# METROPOLITAN GOVERNMENT OF NASHVILLE AND DAVIDSON COUNTY

## STAFF RECOMMENDATION 222 3<sup>rd</sup> Avenue North April 15, 2015

**Application:** New construction-addition; Alterations  
**District:** Second Avenue Historic Preservation Zoning Overlay  
**Council District:** 19  
**Map and Parcel Number:** 09302315900  
**Applicant:** Brent Houck, AIA  
**Project Lead:** Robin Zeigler, robin.zeigler@nashville.gov

ROOF DEMOLITION PLAN

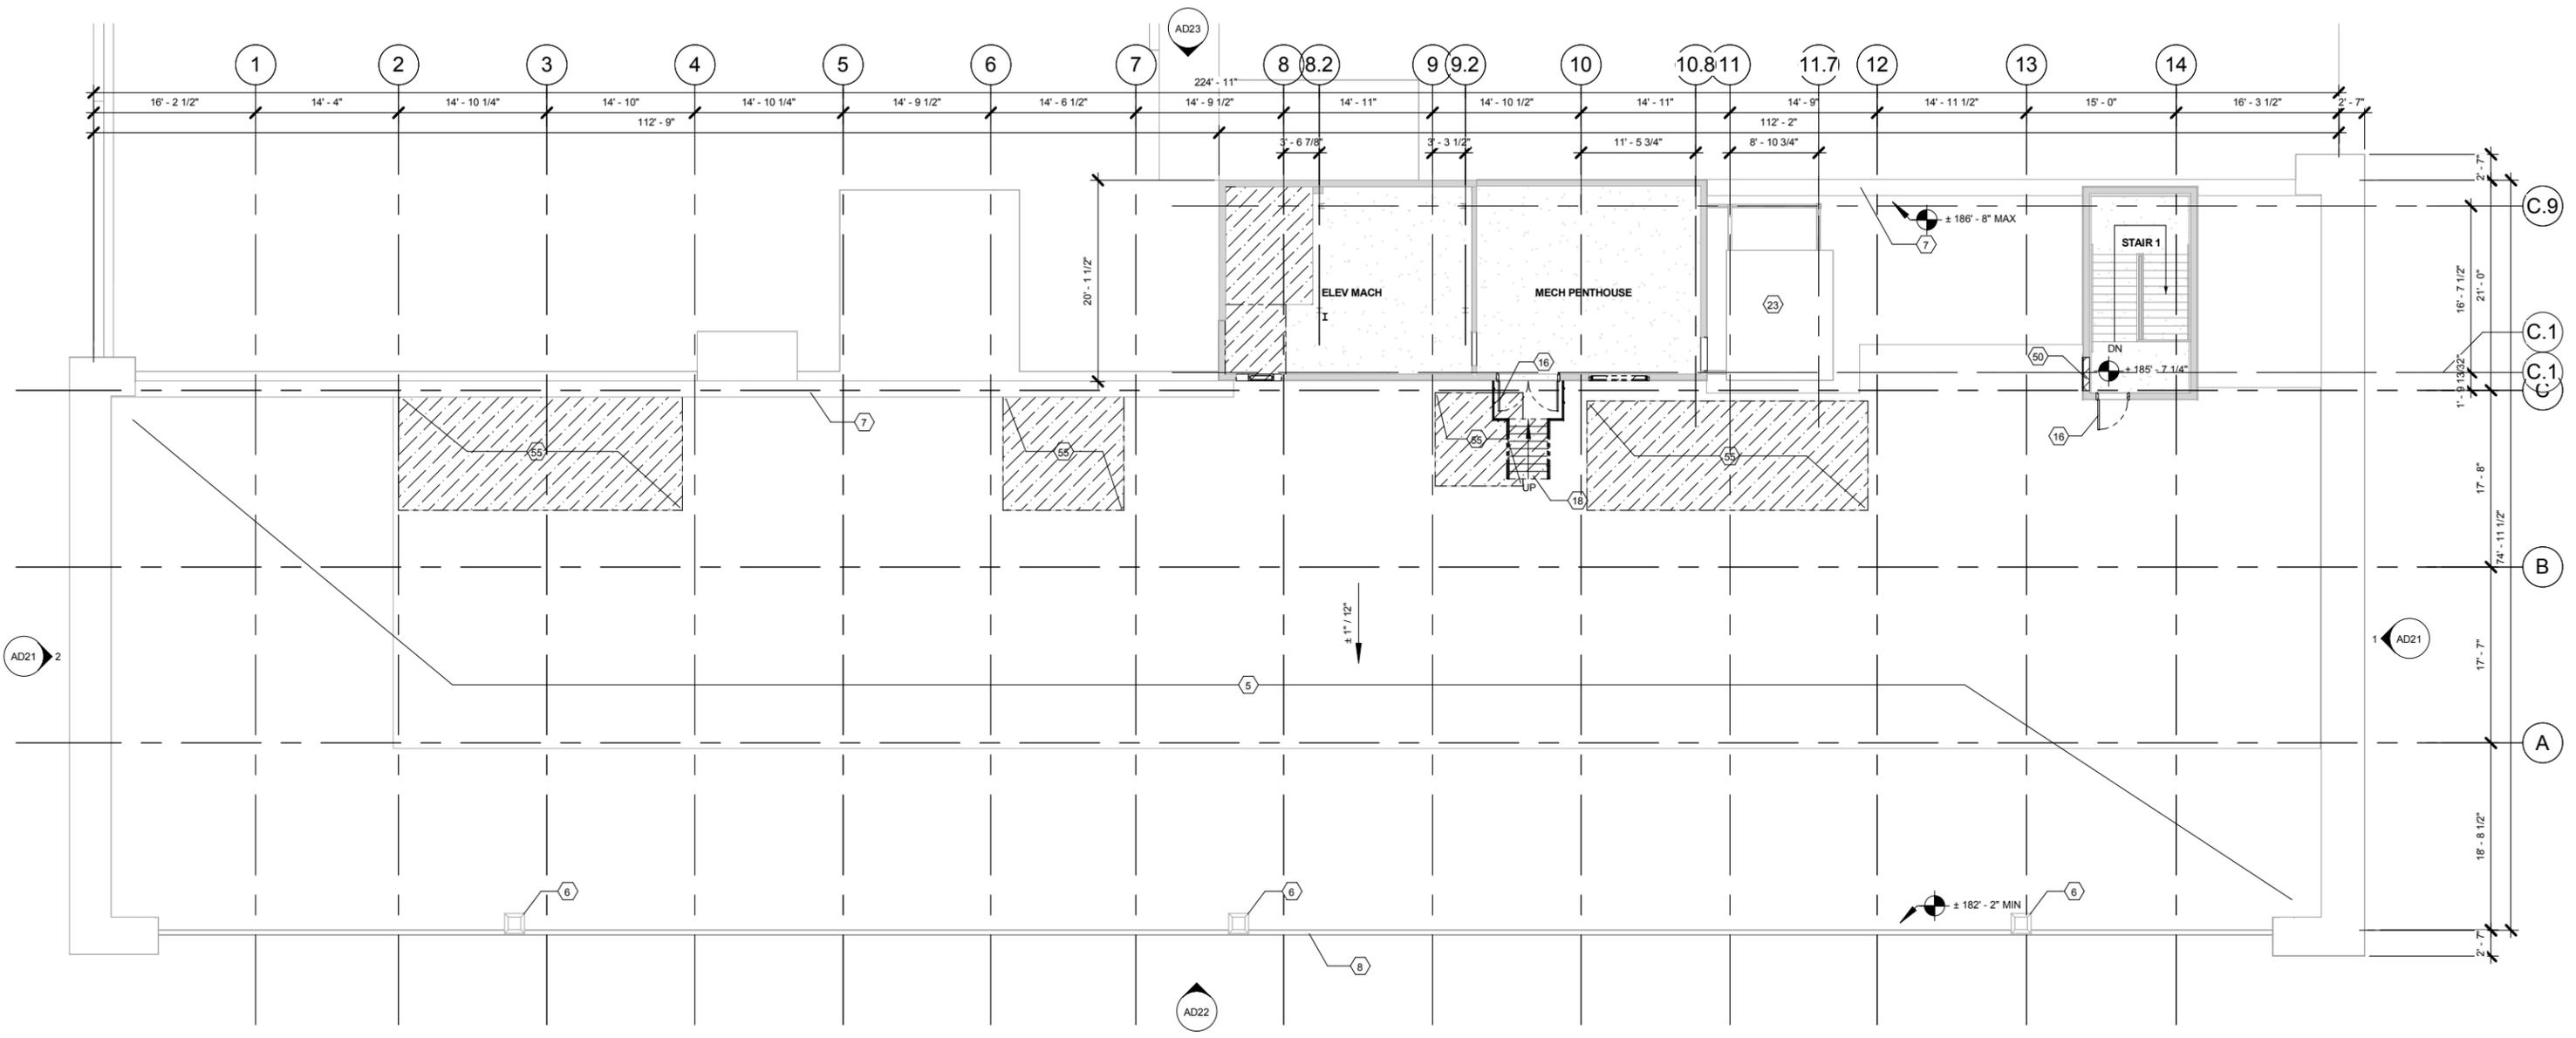
**Roofs & Chimneys:** Elements currently on the roof are not original and will be removed to accommodate a rooftop addition and new mechanicals. (See the analysis of “addition.”) The project meets section II.L.

PROPOSED FIRST FLOOR  
PLAN  
1/16" = 1'-0"

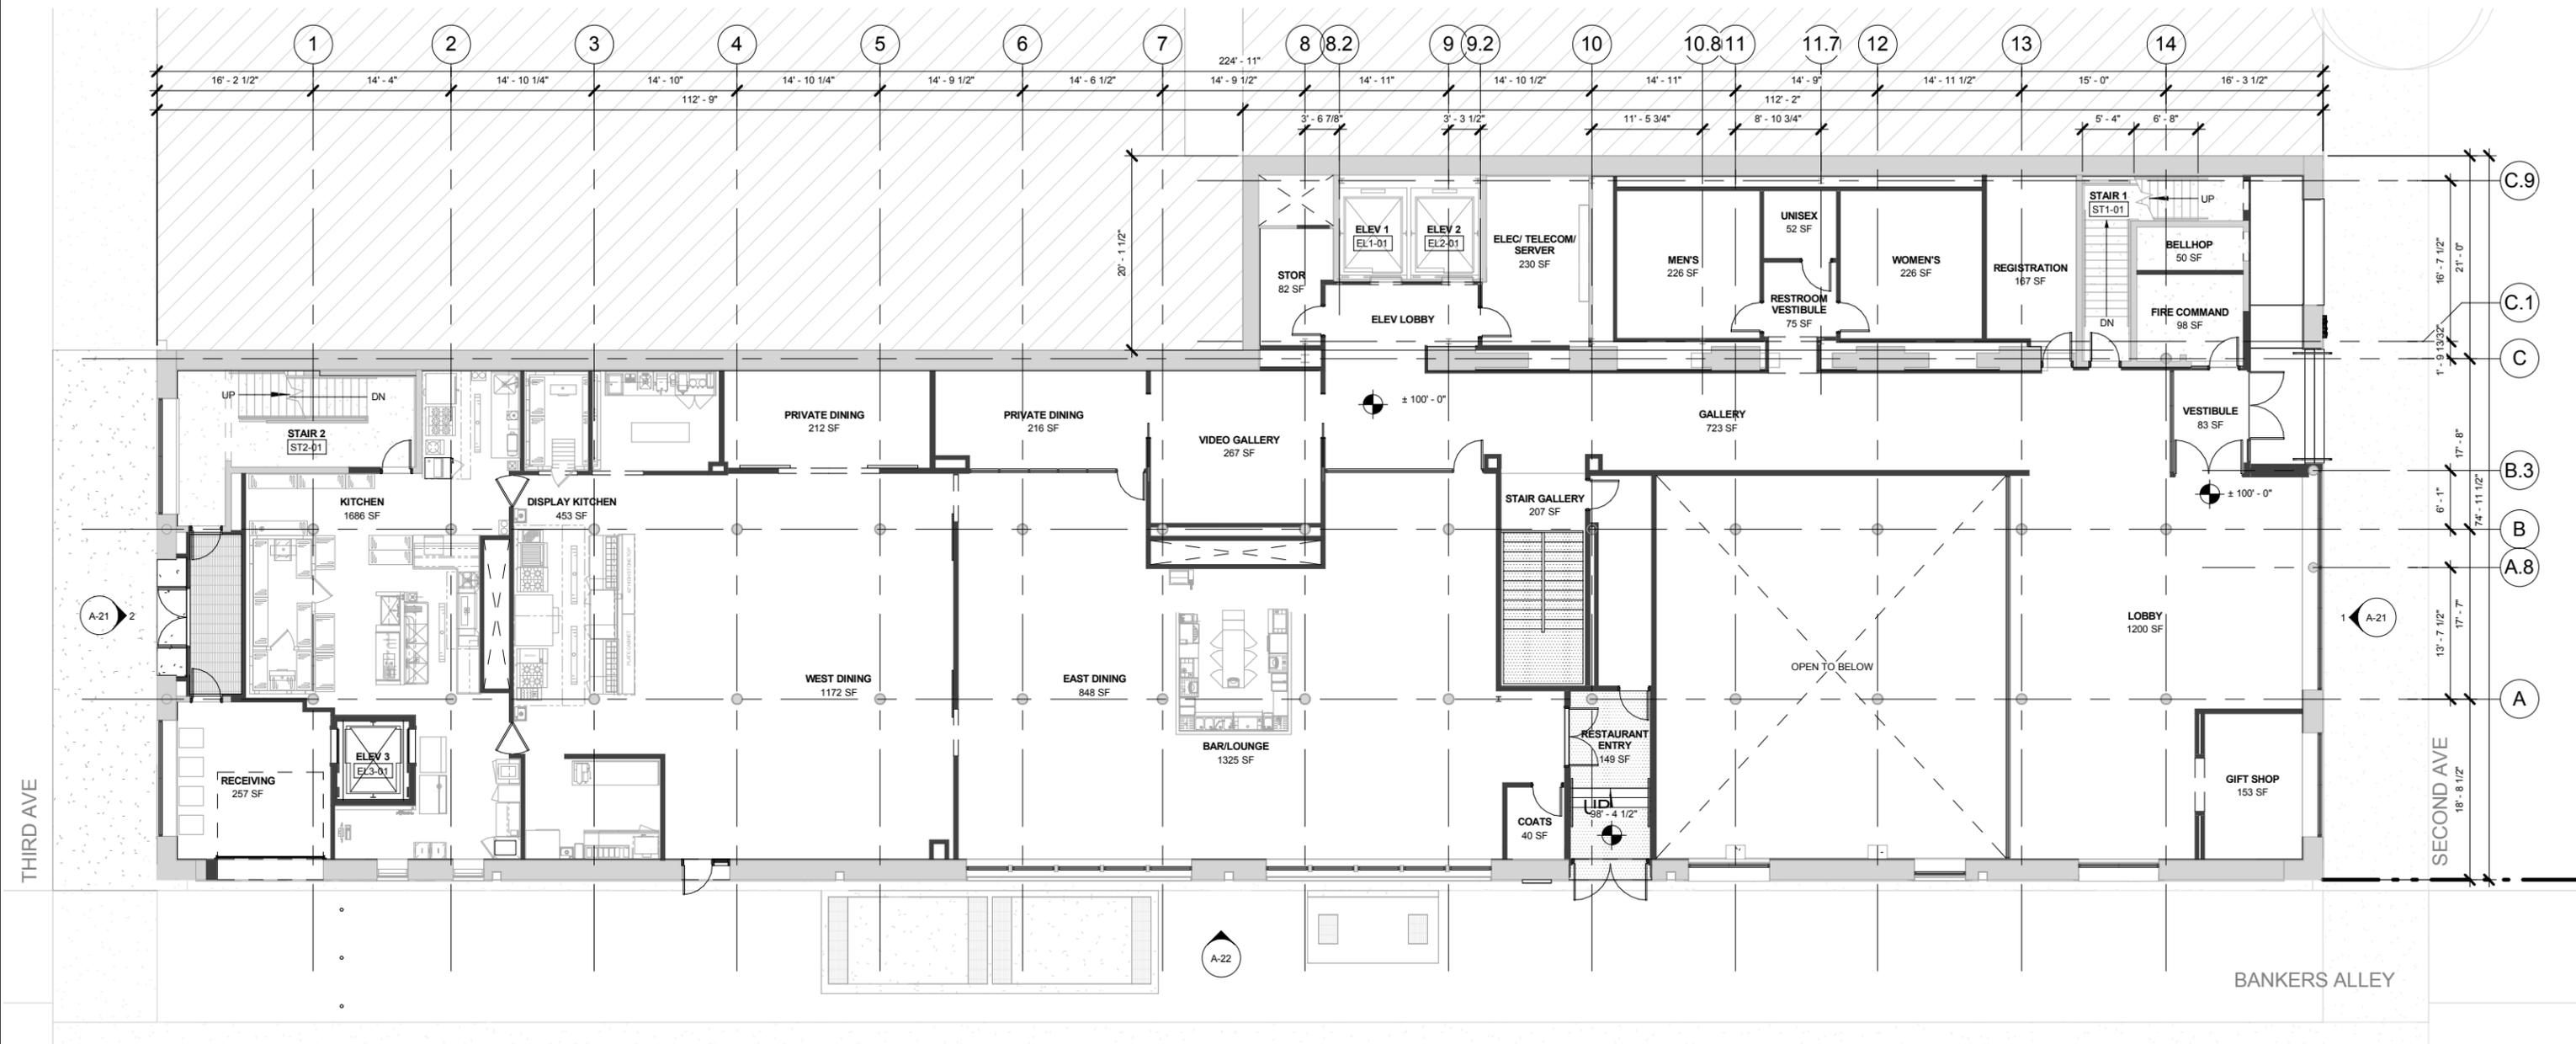
**Rear Elevations:** This building extends from Second Avenue to Third Avenue with storefronts on both sides. The true “rear elevation” is Bank Alley, which will include one roll-up door; otherwise the majority of service-oriented elements will be located on the rooftop. The current gutter locations will remain. The project meets sections II.N-Q.

**Awnings & Canopies:** Metal canopies will be added to the rooftop addition (see analysis of addition) and the new entrance on Bank Alley. The awning on Bank Alley will be a flat-metal awning just over the entrance. The plans state that lighting will be integrated; however, the applicant has told staff that is not the case. Without lighting beneath the awning, it meets section II.R.

- Applicant seeks administrative approval of materials and methods for cleaning and repair of masonry;
- No lighting be integrated into awnings;
- Applicant seeks administrative approval of materials to replace the items on the plan shown as EIFS and Krion.

BUILDING ELEVATIONS

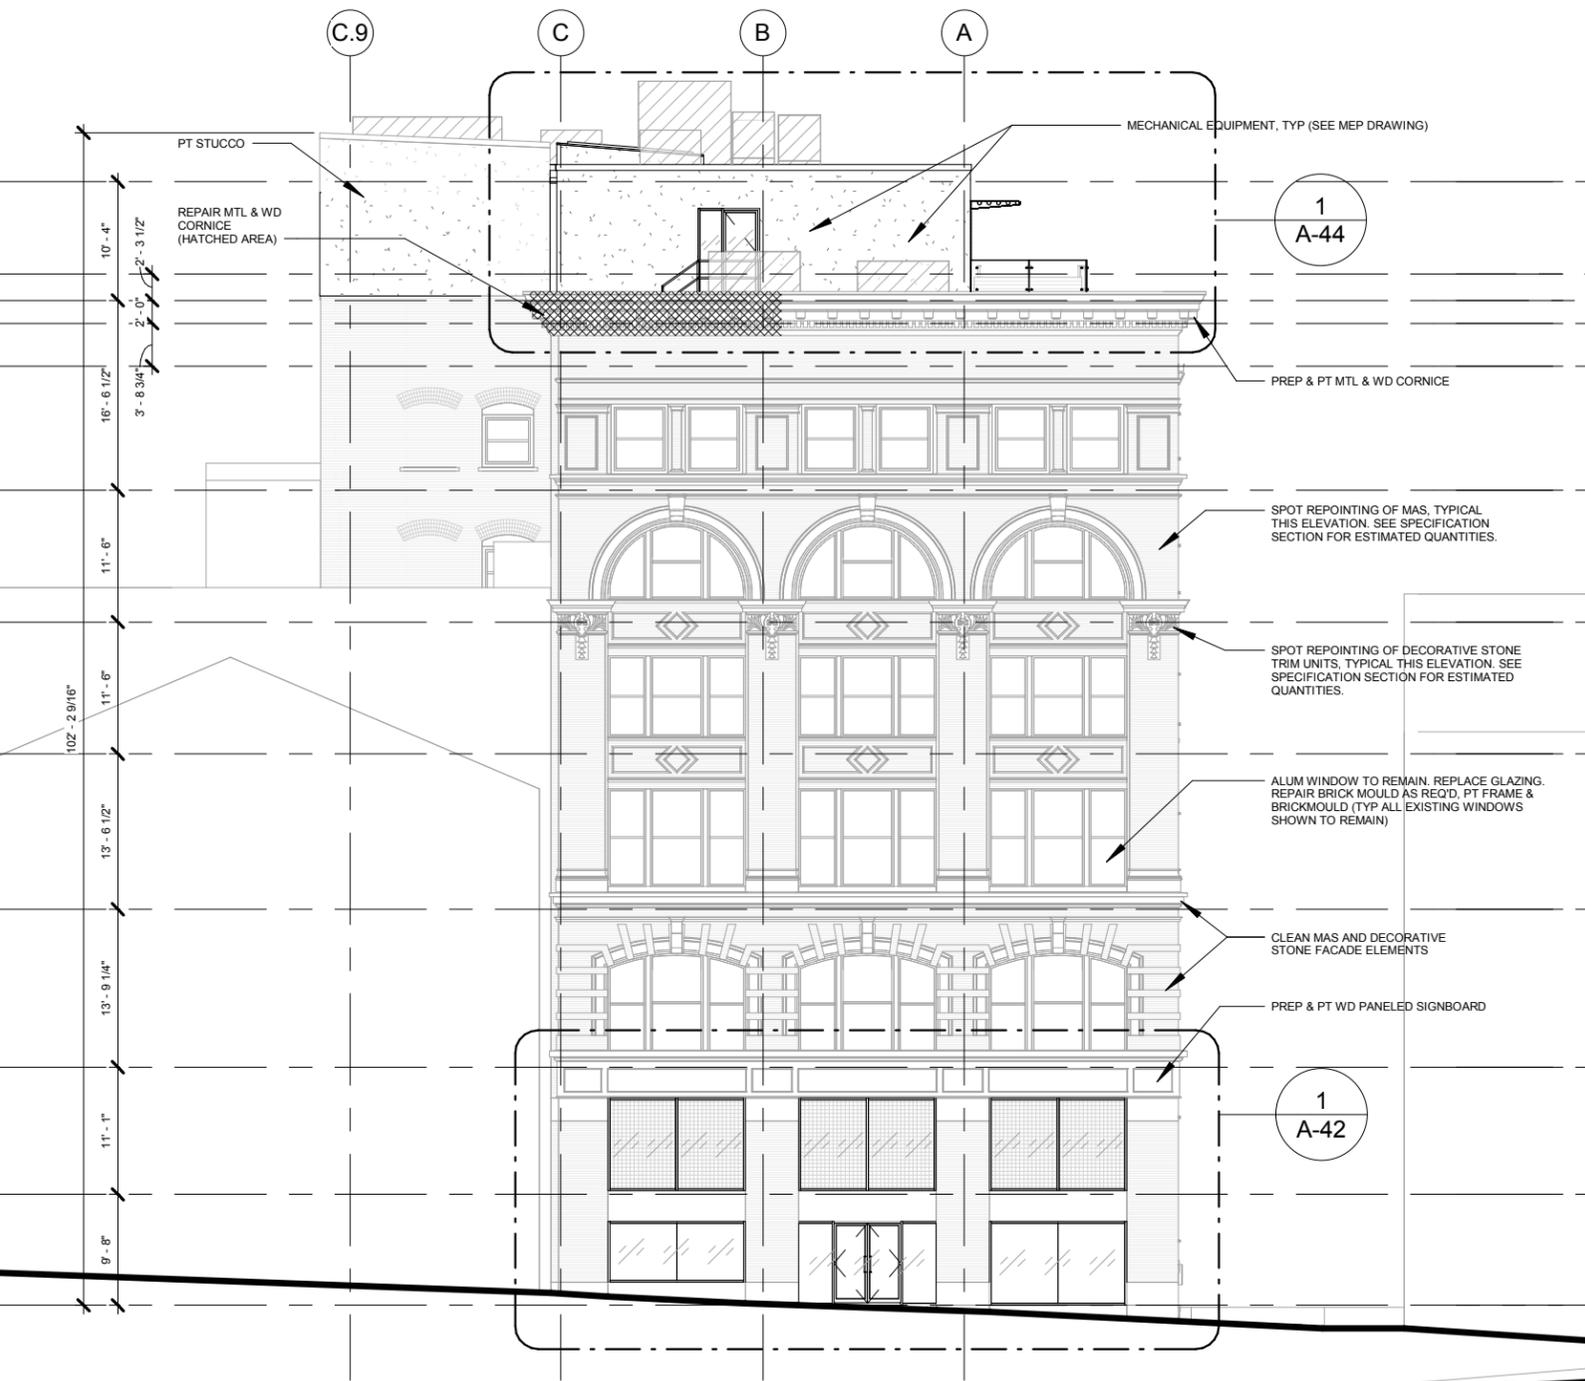
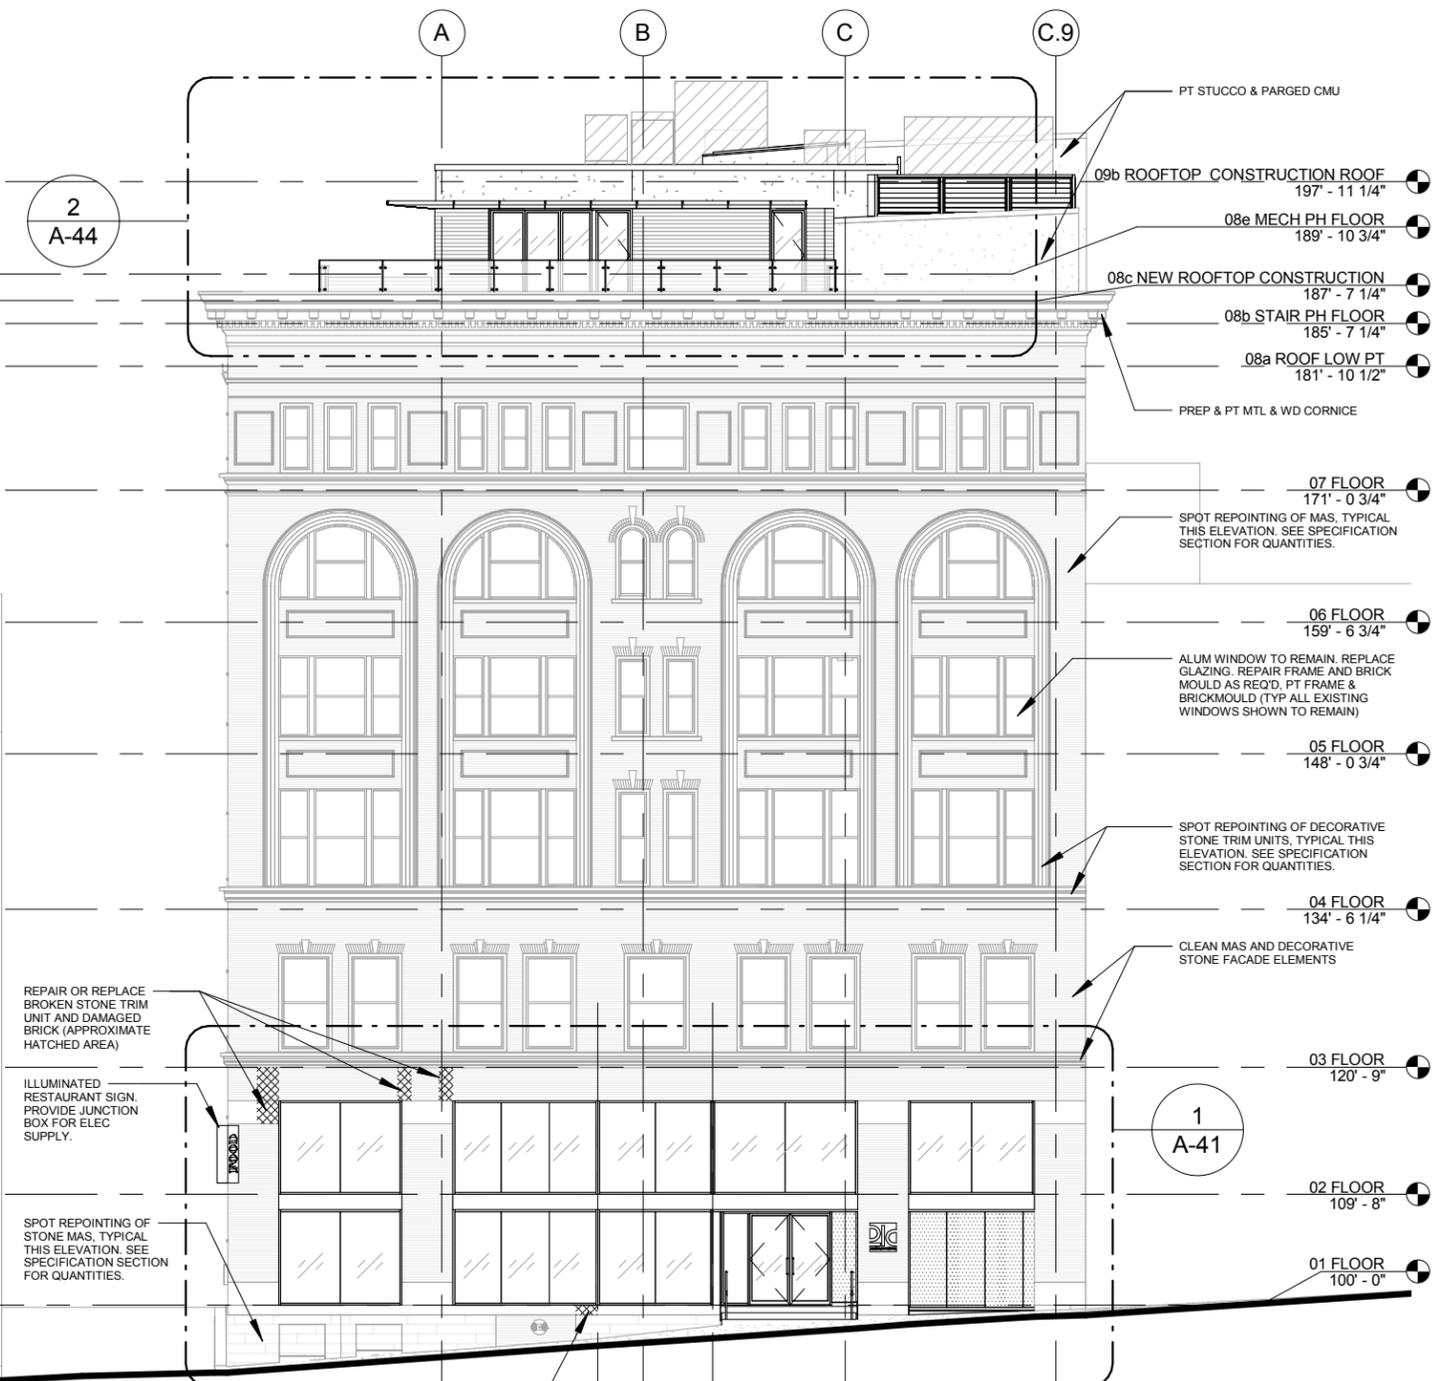
**Storefront:** The existing storefronts are not original. On the Third Avenue side the existing transom will be reinstalled and the storefronts on each side will be a simple open design since the original design is not known. The project meets section II.A-E.

New construction includes a white plastic (Krypton paneling) to the right of the main entrance on Second Avenue. Because this material is not similar to the texture and details of historic masonry, the white color is not compatible with historic materials found in the district, and the location of the material is highly visible, staff finds that it should be replaced with a material appropriate for the overlay in order to meet section III.F. of the design guidelines. All the glazing, with the exception of the rooftop addition will be 100% clear, which is in keeping with section III.F.5. With the condition that appropriate materials be administratively approved to replace the EIFS and Krypton, Staff finds the project meets section III.F

**Signage:** The project includes two signs. One is a wall sign located on the pilaster to the right of the primary entrance on Second Avenue. The other is blade sign located at the alley entrance. This entrance also includes a lighted menu board.
